# IDAHO DEPARTMENT OF WATER RESOURCES

## T15S, R11E, S16, S17 & S21

CLAIM(S): 51-00123

OWNER(S): BRACKETT LIVESTOCK

## T15S, R11E, S16, S17 & S21

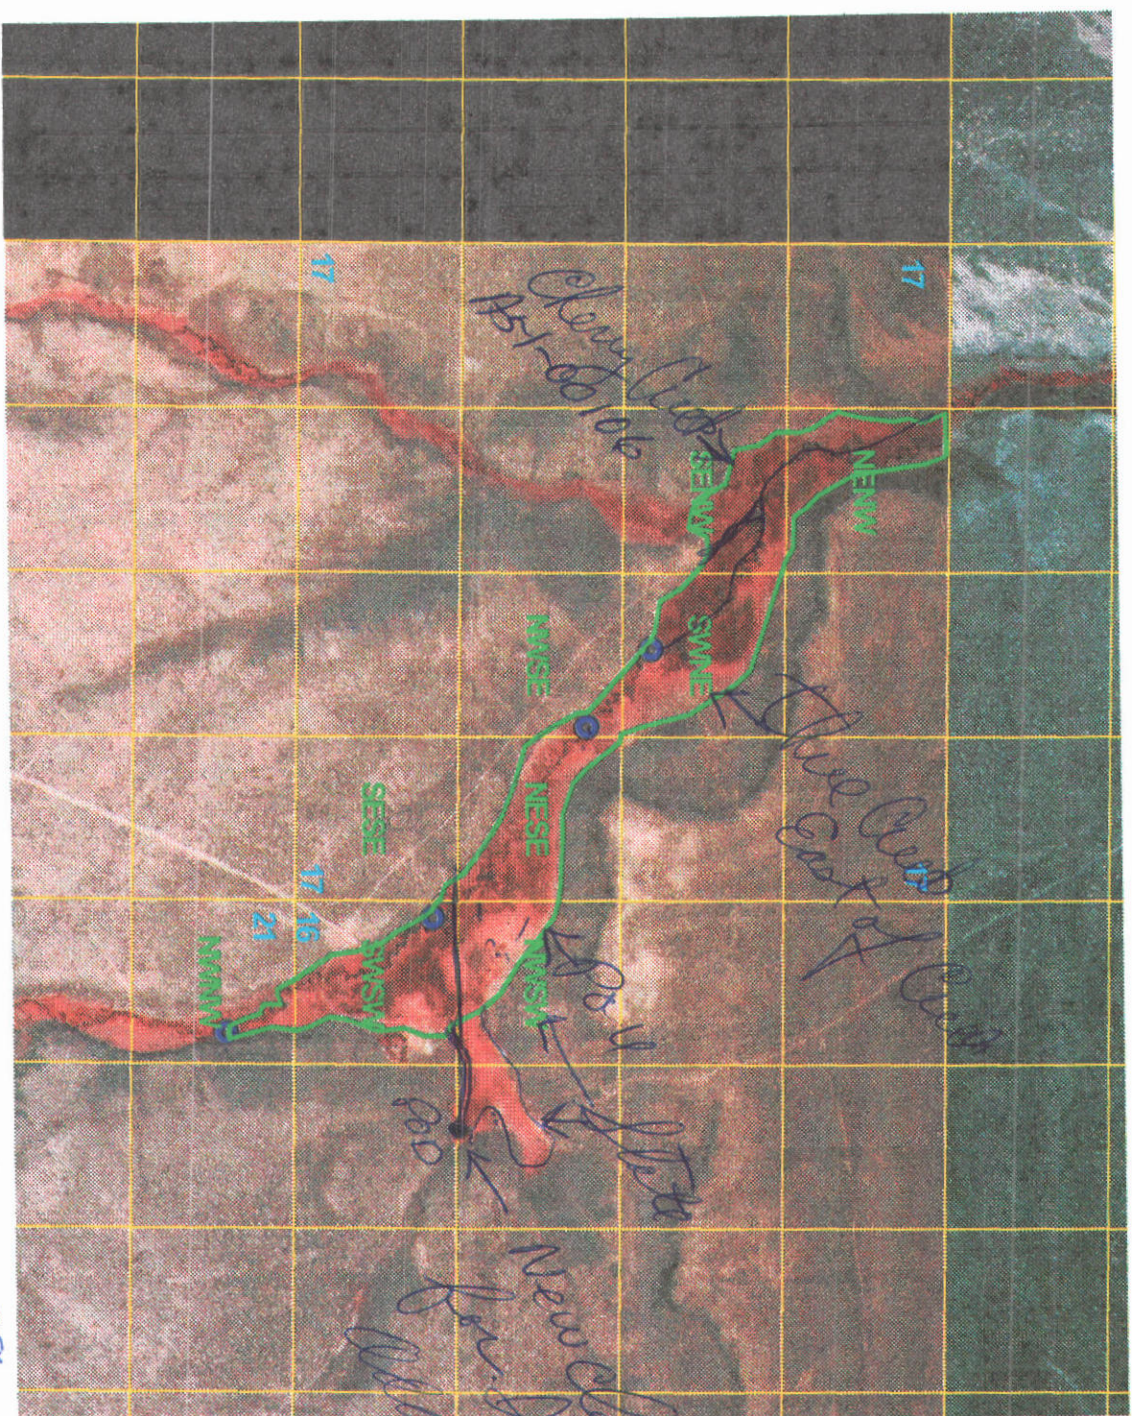
POD 2 OR.

8-20-98 - NOC meeting with  
 Bert Brackett.  
 He will advise us about state land.
